ERM Reference: 0488846

**Subject: Glebe Island Throughput Increase Project Noise Impact Assessment (NIA) – Addendum**

## APPENDIX A – ERM RESPONSE TO COMMENTS

B.1 Updated Night-time Contours

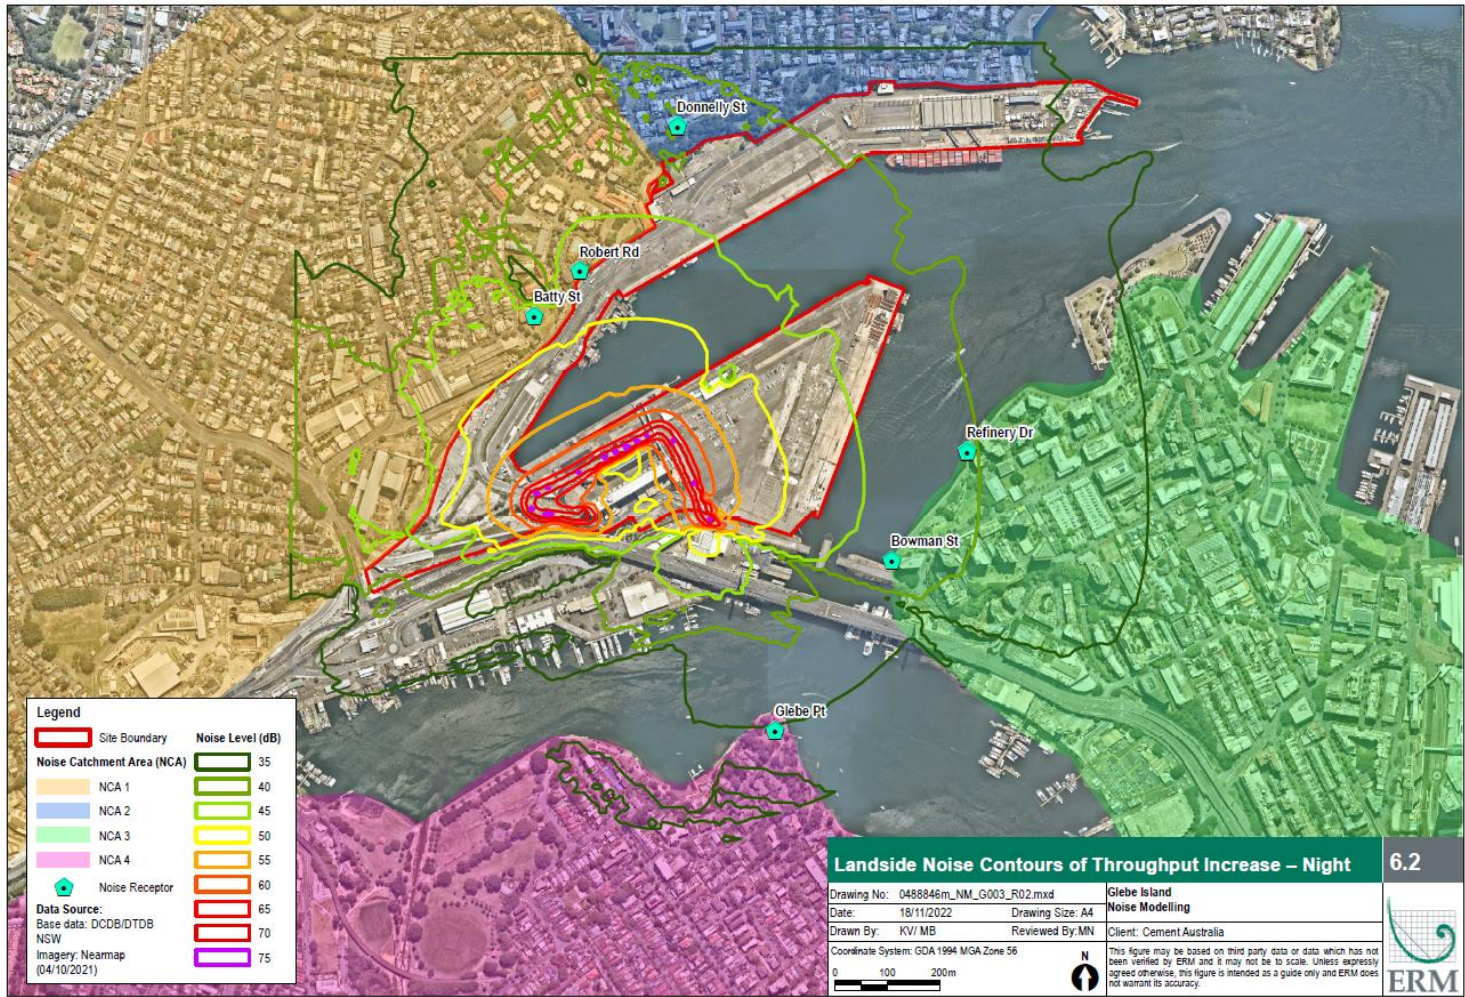
Item	Agency	Feedback / RFI / Comment from Agency	ERM Response	Detailed Response Reference
4	EPA	The NIA indicates at section 6.2 that: "The difference between the day/evening and night-time noise contours is the truck movements which are at a lower frequency in the night-time period". However, the night-time contours in Figure 6.2 are higher than the daytime levels in Figure 6.1. -additionally, the contours indicate higher noise levels than the levels reported in Table 6.2. This anomaly needs to be explained and justified.	We acknowledge the graphics error in the night-time noise contours in Figure 6.1. The model has been re-run and checked. Revised noise contours are provided in Appendix B.	Refer to Appendix B.1
5	EPA	<p>Section 6.1.3 of the NIA indicates that: "The SWL [sound power level] for facility mechanical equipment were based on representative data from ERM's database". A single sound power level has been presented in Table 6.1 for "Facility Mechanical Equipment". Given that the facility is existing and no changes to mechanical plant are proposed, the sound power levels used in the assessment should be based on measurement of the existing plant and equipment. Significant noise sources should be identified through site surveys, and the location, height and sound power level established, reported and used in the noise model.</p> <p><b><i>The current approach to model facility mechanical plant and equipment is considered inadequate.</i></b></p>	<p>Following EPA's feedback, ERM visited the Cement Australia Glebe Island Silos site on the 1<sup>st</sup> of November 2022 to conduct sound pressure level measurements of mechanical equipment noise from the facility. The full measurement details are presented in Appendix B.</p> <p>We wish to clarify that the facility mechanical equipment is fully enclosed, and the noise breakout is through the louvres from the blowers located at the silos.</p> <p>The noise measurements indicate that current noise levels of the blowers at the site are lower than the assumed SWL for facility mechanical equipment in the submitted NIA. ERM notes that the main noise contributor at the facility are the truck movements meaning that updating the SWL for facility mechanical equipment would result into no changes to the predicted noise impact of the throughput capacity increase.</p>	Refer to Appendix B.2

Figure B–1 Measurement Location

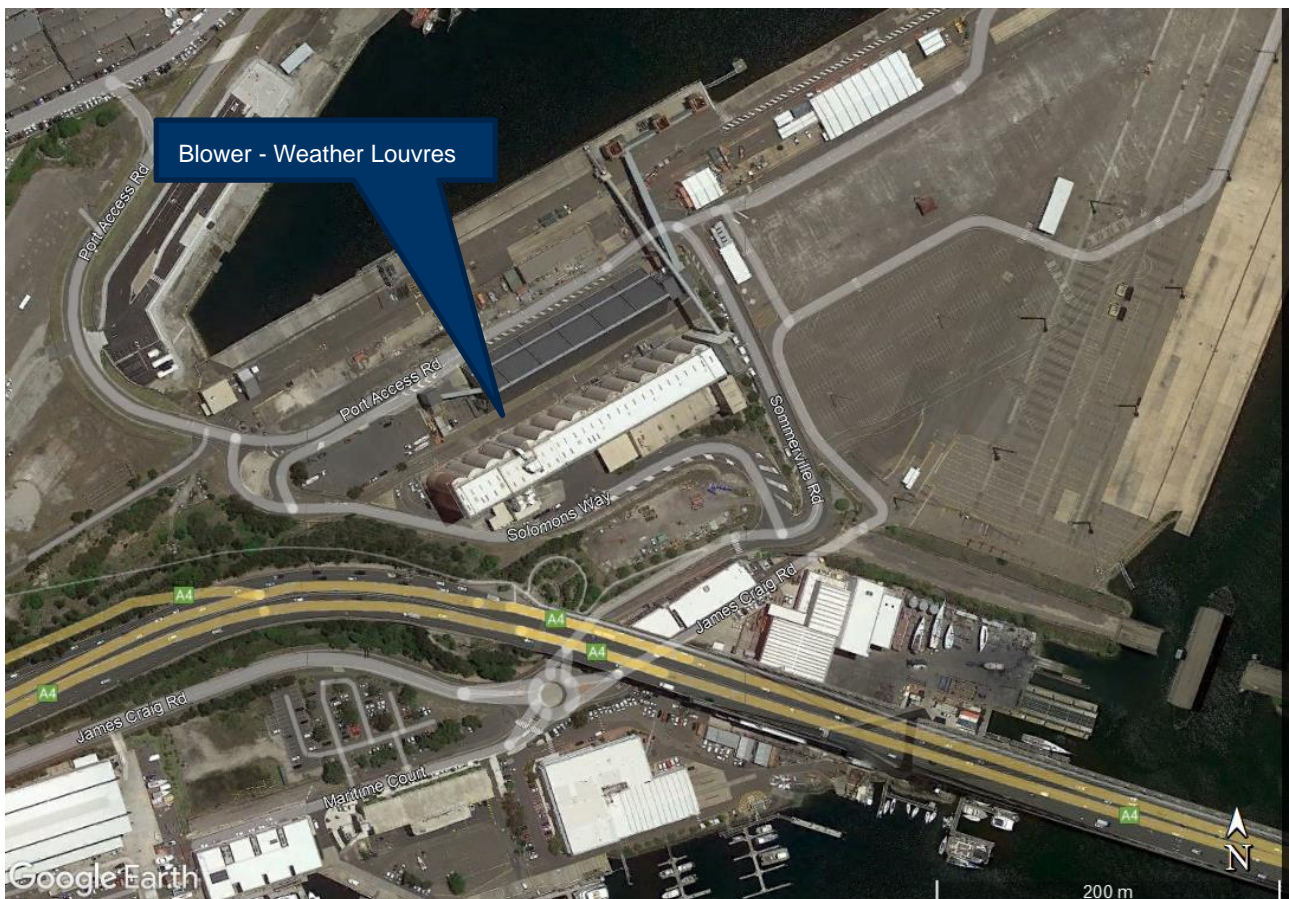
Item	Agency	Feedback / RFI / Comment from Agency	ERM Response	Detailed Response Reference
6	EPA	Section 6.1.3 of the NIA also indicates that: "Night-time measurements were used for calibration purposes as they were less influenced by noise sources unrelated to port activities", however no further details are provided about model calibration or validation.	<p>We wish to retract the following first paragraph of Section 6.1.3:</p> <p>"The SWL for unloading operations were calculated and calibrated from measurements conducted by ERM and SLR, as presented in Section 3.2 of this report. Night-time measurements were used for calibration purposes as they were less influenced by noise sources unrelated to the port's activity."</p> <p>The dominant noise sources and associated Sound Power Levels assumed in the model for the landside noise assessment are indicated in Table 6.1 of the report.</p>	-
7	EPA	<p>Table 6.1 of the NIA indicates that trucks were modelled using a line source.</p> <p><b><i>Additional detail is required for example assumed speed profile through the site, source height, etc.</i></b></p>	<p>ERM provides the following additional information in regard to the truck movements modelled as a line source as indicated in Table 6.1 in the NIA:</p> <ul style="list-style-type: none"> <li>■ A constant movement speed of 20 km/h was assumed.</li> <li>■ The line source was at an emission height of 2.5m relative to the ground.</li> </ul>	-

The sound power level from the louvres is expected to be 81 dB(A). By comparison, the modelling conducted previously by ERM referenced a sound power level of 96 dB(A). Therefore, we conclude that the assessment of facility mechanical noise emissions has been conservative. Notwithstanding, we note that outdoor truck movement noise dominates site emissions and the predicted landside noise levels are unaffected.

**Figure B–3** Extract from *Major civil construction between The Bays and Sydney CBD Environmental Impact Statement 2021 Technical Paper 2 Noise and Vibration (SLR 2021)*

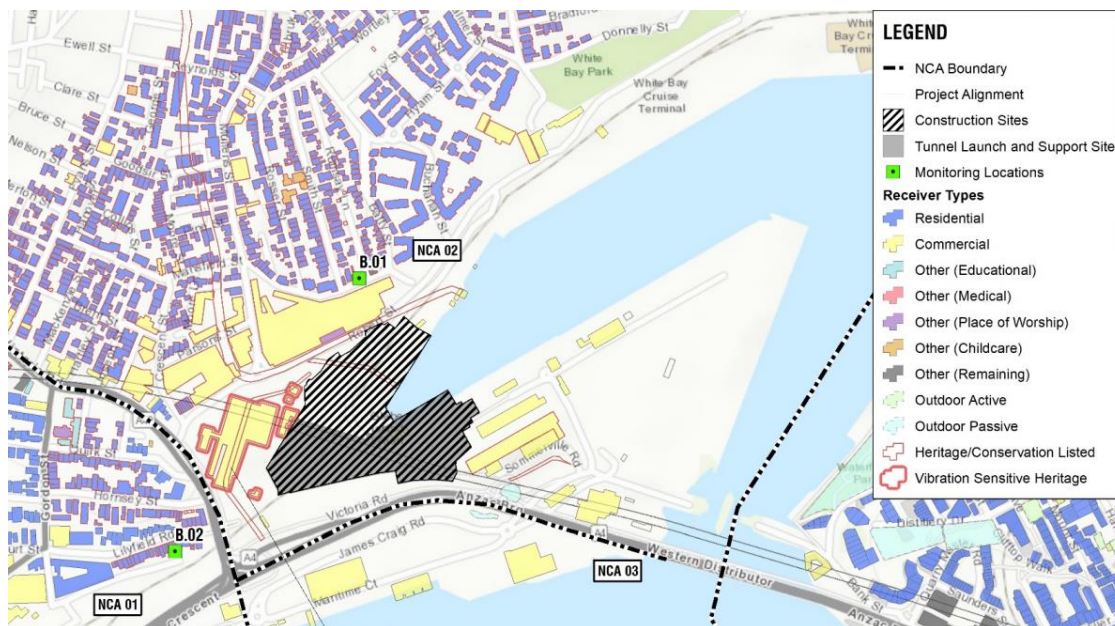
Item	Agency	Feedback / RFI / Comment from Agency	ERM Response	Detailed Response Reference
		<p>receiver wind speeds between 1-5m/s or a well-developed ground-based temperature inversion.</p> <p><b><i>Additional clarification / explanation of the commentary in the NIA as to whether the model has considered noise enhancing or “neutral” conditions while implementing the ISO9613 algorithms is required.</i></b></p>	<p>surrounding land areas 50% acoustically reflective to represent a conservative modelling output."</p>	
9	EPA	<p>Cumulative impacts from the increased throughput and existing operations are reported in the section 6.3 of the NIA. However, only the activities of Hanson Concrete and the increase throughput of the Cement Australia have been considered. Other noise sources such as Gypsum Australia, White Bay Cruise Terminal and the construction of the Metro West etc have not been considered in the cumulative assessment. While the recommendation for the use of a conservative assessment approach under item iii above attempts to address the lack of information about existing landside activities and noise levels, the SEARs require a cumulative assessment.</p> <p><b><i>A cumulative noise impact assessment that includes impacts from existing onsite operations within Glebe Island White Bay and from surrounding developments should be undertaken as required by the SEARs.</i></b></p>	<p>ERM acknowledges that the predicted cumulative impacts presented in Section 6.3 of the NIA consider activities from Hanson Concrete and the increased throughput of Cement Australia only.</p> <p>At the time of writing the report, Hanson Concrete Batching Plant was one of the dominant industrial noise sources influencing the noise environment at the assessed receptors.</p> <p>We acknowledge that a cumulative impact assessment from existing onsite operations at Glebe Island is required by the SEARs and that consideration of just Hanson Concrete Batching Plant is insufficient.</p> <p>A revised cumulative noise assessment is provided in Appendix B considering existing on-site operations and is considered by ERM to satisfy the SEARs.</p>	Refer to Appendix B.3

Item	Agency	Feedback / RFI / Comment from Agency	ERM Response	Detailed Response Reference
10	EPA	<p>While section 6.4 of the NIA suggests that maximum noise events associated with truck movements are predicted to satisfy screening noise levels presented in the assessment, vehicle movements on the site will need to be carefully and effectively managed with both operational controls and management supervision.</p> <p><b><i>DPE may wish to require through any planning approval a heavy vehicle noise management plan to ensure that maximum noise events are effectively controlled and managed through measures including driver training and behaviour, speed limits, road surface etc.</i></b></p>	ERM notes that this recommendation provided by the EPA is addressed to the DPE for consideration. ERM provides no further comment on this item.	-
11	DPE	<p>Section 6.1 of the Noise Impact Assessment (NIA) indicates the incremental noise impacts of the development have been combined with the findings of the NIA prepared by SLR Consulting Pty Ltd in 2018 for the Hanson development to determine landside cumulative noise impacts of the development. However, it is not clear the extent of noise sources which have been included in the cumulative assessment.</p> <p><b><i>The Department requests confirmation on the noise sources considered in the cumulative noise impact assessment.</i></b></p>	The cumulative noise assessment has been revised in Item 9 and Appendix B.3.	-

The cumulative impact assessment indicates that no exceedances of the Precinct Cumulative Noise Limits are predicted at all NCAs for all periods.
